RE: WDNR Comments on 60% Remedial Action Design Report

The *60% Remedial Action Design Report - Upland Area (RAD)* was prepared by Foth Infrastructure & Environment LLC (Foth) and submitted to Wisconsin Department of Natural Resources (WDNR) on behalf of Superior Water, Light & Power, (SWL&P) on March 19, 2021. WDNR provided comments in a 60% *RAD* approval letter received via email on April 20, 2021 (dated April 16, 2021).

May 21, 2021

This document provides Superior Water, Light & Power's (SWL&P) response to Wisconsin Department of Natural Resources' (WDNR) comments on the March 2021 *60% Remedial Action Design Report (RAD)*. Key concerns discussed in WDNR's comments are related in the SWL&P responses to the Site's approved Remedial Action Objectives (RAOs), as the design efforts are critically focused on the development of a remedial action (RA) to achieve the RAOs.

RAOR Figure 3-2

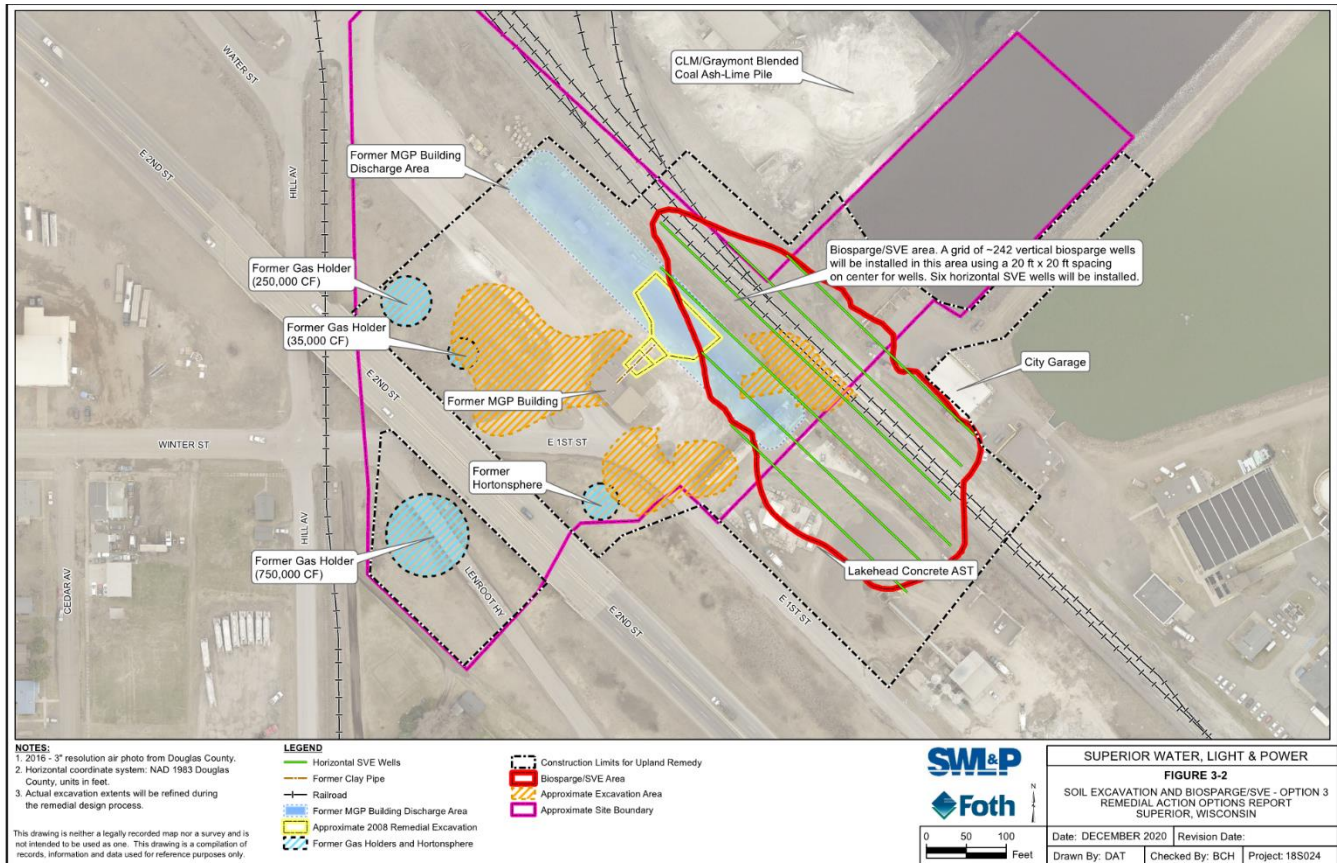
WDNR Comment RAD Section 1.3.1:

The soil excavation limits selected for the Hortonsphere, gas holder, and PAH discharge areas are not based on remediating soil contamination to a concentration the DNR considers protective of groundwater quality. Supplemental RA, biosparge and soil vapor extraction (SVE), will be performed in the MGP discharge area which should reduce concentrations of some of the more volatile contaminants in this area of the Site but may leave in place high concentrations of PAHs. The Hortonsphere and the gas holder areas currently have no active supplemental RA planned and as a result will leave very high concentrations of contaminants left in place following the excavation activities. SWL&P is relying on natural attenuation as the final RA for the remaining contamination. The DNR believes a final natural attenuation RA may not be adequate for the high concentrations of contamination expected to remain following the active RA of excavation, air sparging and SVE operation. When the active RA is completed, SWL&P will need to complete an evaluation of Site conditions and make a determination if natural attenuation is appropriate as a performance standard for the remaining contamination. If, following RA activities, the closure requirements contained in Wis. Admin. Code ch. NR726 cannot be met, the DNR may conclude under Wis. Admin. Code §726.13 (2) (b) that additional response actions are necessary.

- ◆ SWL&P Response: WDNR comment on Section 1.3.1 focuses on attainment of RAO 2: Reduce contaminant mass in the subsurface soil (>4 feet bgs). The RAs for the selected remedy for the Site are shown on Figure 3-2 of the *RAOR*. The *RAOR* evaluated the projected net soil contaminant mass removal from excavation, the concentrations of residual contamination in soil remaining after excavation and after biosparging treatment, and the potential for natural attenuation to achieve further mass removal (see Appendix A of the *RAOR*). Excavation removal of total BTEX and total PAH mass in the former gas holder (35,000 CF) and former Hortonsphere areas is estimated to be at 95%, which is substantial and will not leave any significant residual contamination. Removal of total BTEX and total naphthalene mass in the former MGP building discharge area through focused excavation is approximately 60% of total PAH, which is also significant. Additional total BTEX and total PAH degradation will occur with the biosparge/SVE system, operated and monitored to asymptotic conditions, which is anticipated to result in even further reduction in total BTEX and total PAH. The extent of removal by excavation and biosparge/SVE is limited by utilities, railroad tracks, site structures, and gravel piles.

- ◆ The Pre-Design Investigation demonstrated that Site chemistry and microbiology favor continued and consistent reductions in total BTEX and total PAH as a result of monitored natural attenuation, enhanced by ORC, which is supported by other relevant literature citations provided in Appendix A of the *RAOR*.

- ◆ SWL&P presented the detailed remedial approach described above and in the Remedial Design in several conference calls with WDNR; in fact, SWL&P added the additional focused excavation in the former MGP discharge areas at the request of WDNR (RAOR Figure 3-2 below). WDNR concurred that the approach was acceptable in latter conference calls on this matter; SWL&P therefore presented this soils remediation plan in the RAOR, and the RAOR was approved by WDNR. We believe WDNR agreed on this remedial approach for impacted soils in these areas, and that there is no basis to revisit that soils objective in the Remedial Design.

Figure 1. Mass Benzene vs. Volume of Soil (Rationale for selecting 5 ppm benzene)

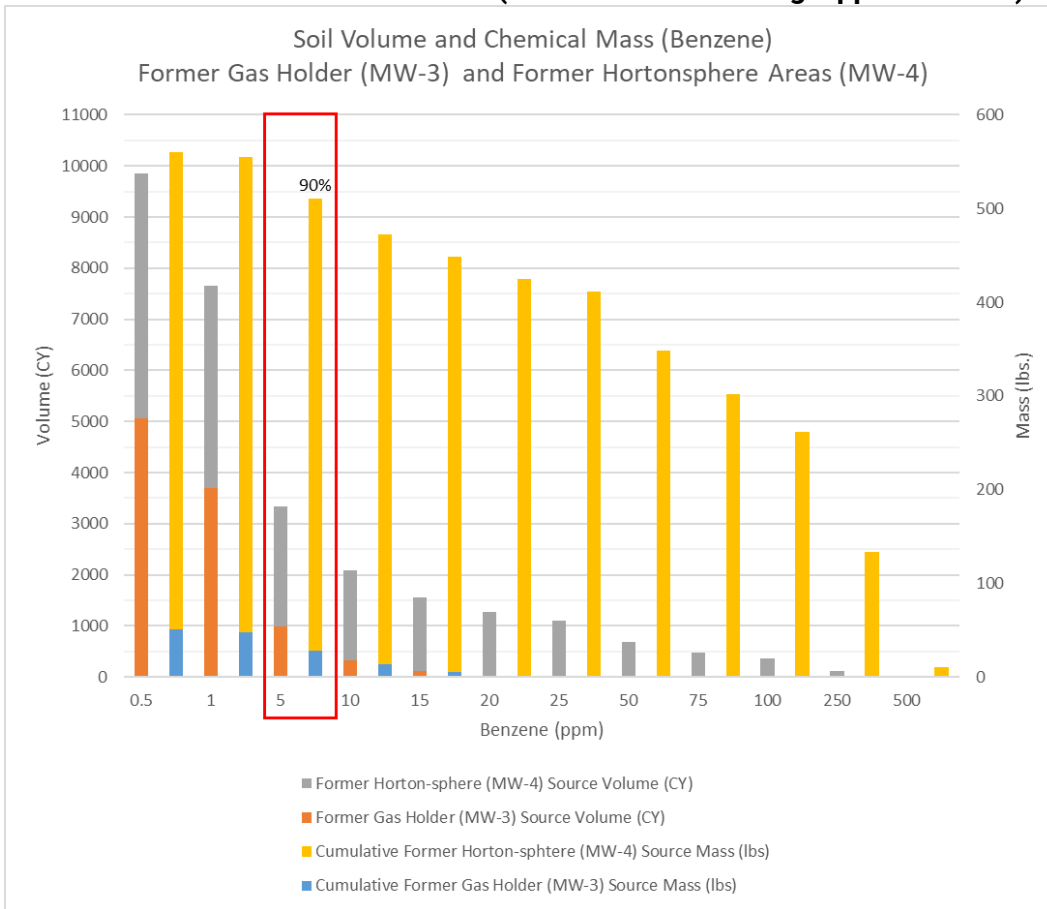
WDNR Comment RAD Section 2.6.1:

Excavating soil in the MGP gas holder and Hortonsphere area only to the industrial RCLs will leave a large mass of contamination in place that poses a threat to groundwater quality. The DNR was under the impression from the language in Section 3.3.2 of the January 2021 RAOR – Upland Area that a greater volume of soil was to be excavated from these areas.

In addition to comparison of confirmation soil samples to standards in the *FSP*, comparison of the results to the Wis. Admin. Code ch. NR720 RCLs for the protection of groundwater is also necessary. The Wis. Admin. Code NR720 RCLs for the protection of groundwater are not referenced in the *FSP*. Clarification is needed on the expected contamination that will remain following excavation in the area of the MGP gas holder and the Hortonsphere.

- ♦ SWL&P Response: Selected Option 3, as stated includes focused excavation of 8,500 cy of soil from the former gas holder (35,000 CF) and former Hortonsphere areas followed by in-situ remediation by biosparging and SVE, respectively, in the former MGP building discharge area, and excavation of 4,500 cy at the former MGP discharge area. RAOs 1, 2 and 3 will be achieved, as described in the WDNR-approved *RAOR* and further presented and described in the *RAD*. As previously stated, excavation removal of total BTEX and total PAH mass in the former gas holder (35,000 CF) and former Hortonsphere areas is **estimated to be 95%, which is significant**. Removal of total BTEX and total naphthalene mass in the former MGP building discharge area through focused **excavation is approximately 60% of total PAH, which is also significant**. Additional total BTEX and total PAH degradation would occur following excavation with the biosparge/SVE system, with system operated and monitored to asymptotic conditions, which is anticipated to result in even further reduction in total BTEX and total PAH.

Active in-situ remediation in the former gas holder (35,000 CF) and former Hortonsphere was determined to be technically and economically infeasible in the Miller Creek Formation clay. To achieve RAO 2, Option 3 of the *RAD* includes excavating deep soil in these two excavation areas to 5 mg/kg, as a source control action, with the additional performance standard of a low permeability backfill as shown on Figure 1. The contaminant mass removal and low permeability backfill amended with ORC material will further mitigate potential leaching of residual contamination to groundwater.

As stated above, Option 3, the preferred, selected and approved alternative, in the *RAOR* included added focused excavation of 4,500 cy in the biosparge area to

increase the mass of total PAH removed. This additional excavation was requested by WDNR during the RAOR process, discussed and presented to WDNR during the RAOR finalization to remove more contaminant mass from the Site. The total excavation volume of the WDNR approved selected Remedial Option 3, as shown in Appendix B.1 of the 60% Design Report, is 13,000 cy, with 8,500 cy from the former gas holder (35,000 CF) and former Hortonsphere (4,500 cy plus 8,500 cy for a total of 13,000 cy).

The RAOR demonstrated that the amount of mass removed during Option 3 excavation for the former MGP gas holder and the former Hortonsphere will be significant as illustrated on Figure 1 for benzene. The significantly lower mass of residual contamination in soil beneath the excavation would significantly reduce the mass flux from soil to groundwater, which is already negligible and will be further reduced by low permeability backfill and ORC-enhanced continuing natural attenuation of COCs in groundwater. The FSP describes procedures for sampling soil, but the documentation and comparison of concentrations of residual contamination in soil is described in the Upland RAD and the OM&M Plan and summarized in Table 1.
